VARIANCE PROPOSAL PLAN FOR:

Marietta Fish Market, LLC

APPLICANT: <u>Marietta Fish Market, LLC</u>	PETITION NO.: <u>V-28</u>
PHONE: <u>770-422-7016</u>	DATE OF HEARING: <u>04-08-09</u>
REPRESENTATIVE: <u>Parks Huff</u>	PRESENT ZONING: <u>GC</u>
PHONE: <u>770-422-7016</u>	LAND LOT(S): <u>443, 444</u>
PROPERTY LOCATION: <u>Located on the west side of Canton Road, south of Blackwell Road and on the east side of Hilltop Drive.</u>	DISTRICT: <u>16</u>
	SIZE OF TRACT: <u>4.12 acres</u>
	COMMISSION DISTRICT: <u>3</u>

TYPE OF VARIANCE: 1) Reduce the landscape buffer adjacent to residentially zoned property from the required 40 feet to as low as 5 feet; 2) allow temporary parking on a gravel lot on tract A during construction only; 3) waive the width of a drive aisle for 60° parking from 18.5 feet to 13 feet; and 4) waive the front setback on tract C from 50 feet to 37 feet (existing).

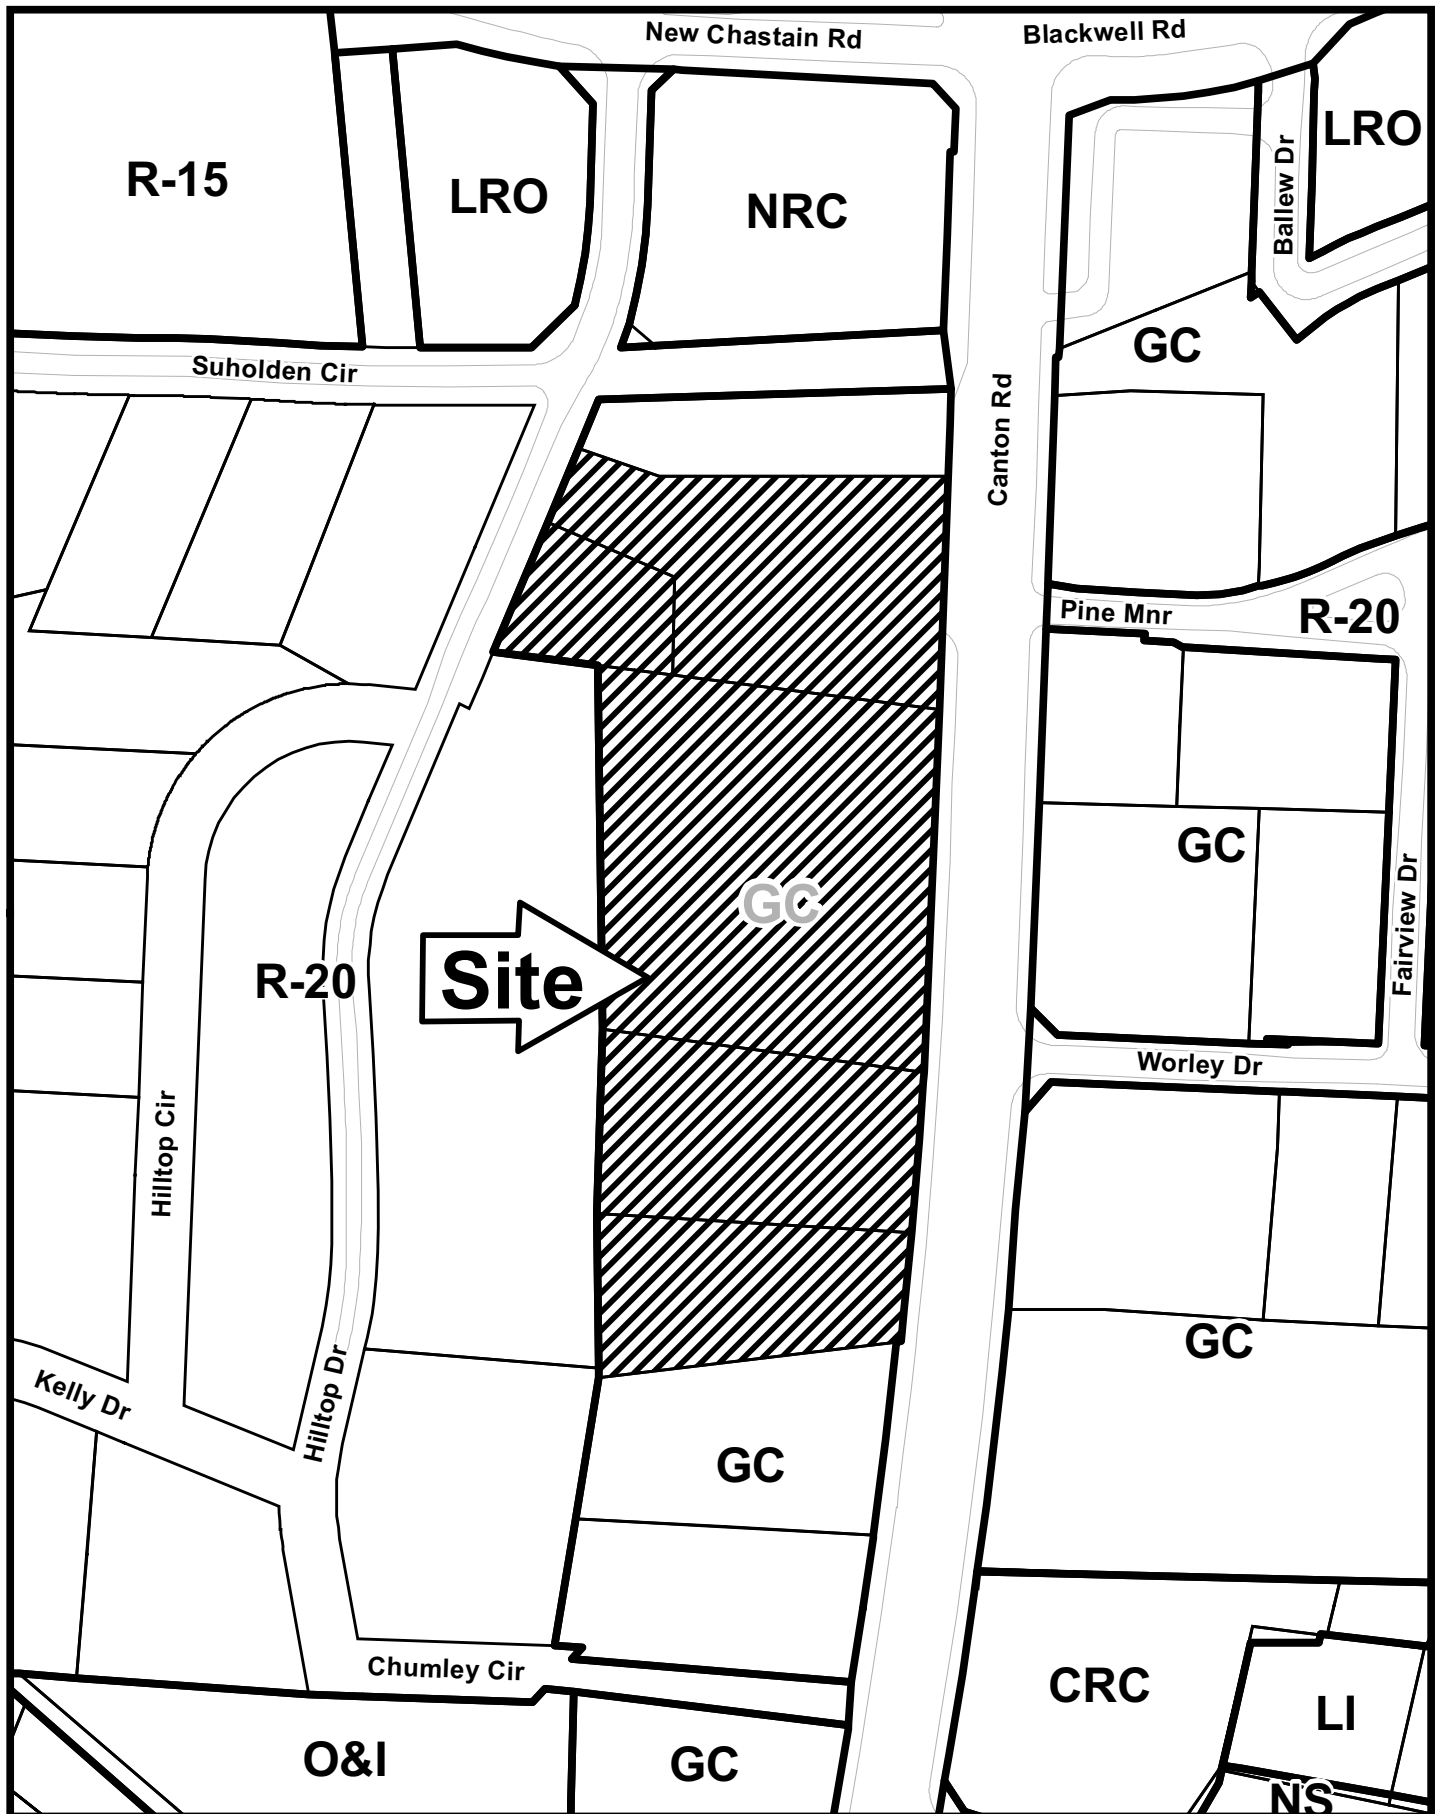
TRAFFIC: Recommend applicant consider entering into a development agreement pursuant to O.C.G.A. 36-71-13 for dedication of the following system improvements to mitigate traffic concerns: a) donation of right-of-way on the west side of Canton Road, a minimum of 50 feet from the roadway centerline; b) donation of right-of-way on the east side of Hilltop Drive, a minimum of 30 feet from the roadway centerline. Recommend closing the northern driveway (first driveway south of the signal). Recommend a deceleration lane for entrance on Canton Road. Recommend one driveway access on Hilltop Drive. Hilltop Drive is a substandard street. Recommend improving Hilltop Drive from along the frontage to the intersection with Suholden Circle to comply with Cobb County Standards. Recommend applicant coordinate with Cobb County DOT prior to development plan approval to ensure compatibility with the proposed Canton Road Safety and Operational Improvement project.

DEVELOPMENT & INSPECTIONS: It is not possible to assess the impact of this buffer reduction without more detailed plans showing how the retaining wall will be built and what grading activity will occur in the buffer area. Staff would not support a buffer reduction unless the area could be planted and maintained properly to achieve the required buffering effect.

STORMWATER MANAGEMENT: Although the proposed land disturbance may be located sufficiently below the existing residences on the hill above to not impact the visual screening currently provided, this proposed parking lot expansion will require significant grading to construct. The existing slopes are extremely steep (1:1) and will either require high retaining walls or excessively steep graded slopes to accomplish. It appears that adequate stormwater quality has been provided for, but space is limited for meeting detention requirements. Unless underground detention is utilized, offsite detention will be required which will not be possible unless the existing downstream storm system has adequate capacity to accommodate the increased peak discharges. If approved, all these issues must be addressed at Plan Review.
